03V-161

G-01516  
JUNE 2003

**SUBJECT: NONCOMPLIANCE RECALL (U.S., EXPORT)**  
**Windshield Washer Pump Fuse on 4000 Series built  
10/24/2000 through 10/15/2001**

Figure 1

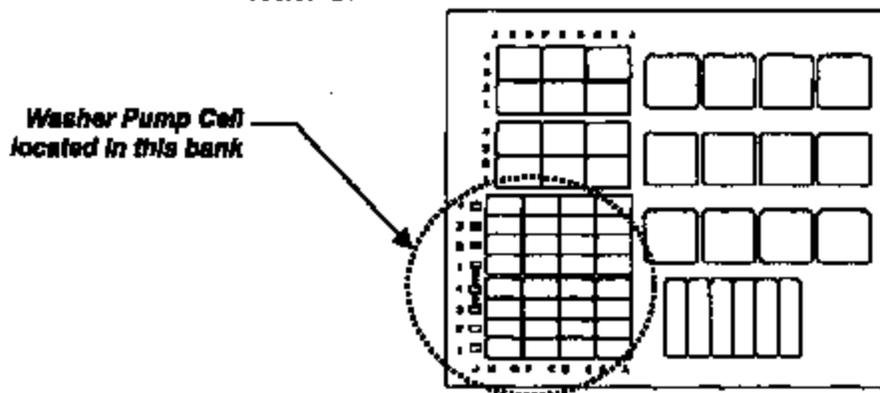
The 5-ampere windshield washer pump fuse, located in the Power Distribution Center, will fail under certain test conditions that render the washer system inoperable. A failure of the windshield washer system is a violation of Federal Motor Vehicle Safety Standard (FMVSS) 104 Section 3.2.

- B. Locate cell labeled, "5A WASHER PUMP," in the lower left bank of cells (see figure 1).
- If the washer pump cell indicates, "10A WASHER PUMP," this truck does NOT require this recall.
  - If the washer pump cell indicates, "5A WASHER PUMP," then continue to letter C.

- C. Thoroughly clean and dry the area in and around the, "5A WASHER PUMP," cell so the new label will adhere properly.
- D. Place the new label over the, "5A WASHER PUMP," cell so it now indicates, "10A WASHER PUMP."
- E. Locate and remove the 5-ampere washer pump fuse in the PDC. Replace with a 10-ampere fuse.
- F. Reinstall PDC lid.

Figure 3

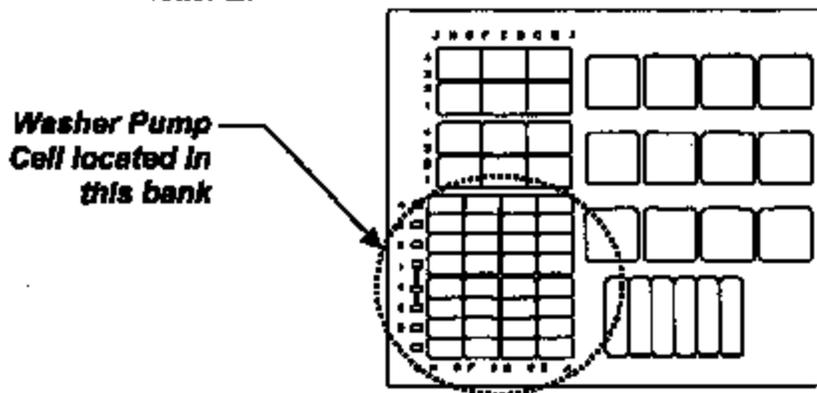
- C. Locate the PDC Fuse Identify Label on the underside of the lid.
- D. Locate cell labeled, "5A WASHER PUMP," in the lower left bank of cells (see figure 3).
- If your washer pump cell indicates, "10A WASHER PUMP," you do not need this recall. Skip down to letter K for instructions on filling out the, "AUTHORIZATION FOR RECALL SERVICE," card.
  - If your washer pump cell indicates, "5A WASHER PUMP," then continue to letter E.

- E. Thoroughly clean and dry the area in and around the, "5A WASHER PUMP," cell so the new label will adhere properly
- F. Place the new label over the, "5A WASHER PUMP," cell so it now indicates, "10A WASHER PUMP."
- G. Locate and remove the 5-ampere washer pump fuse in the PDC. Replace with included 10-ampere fuse.
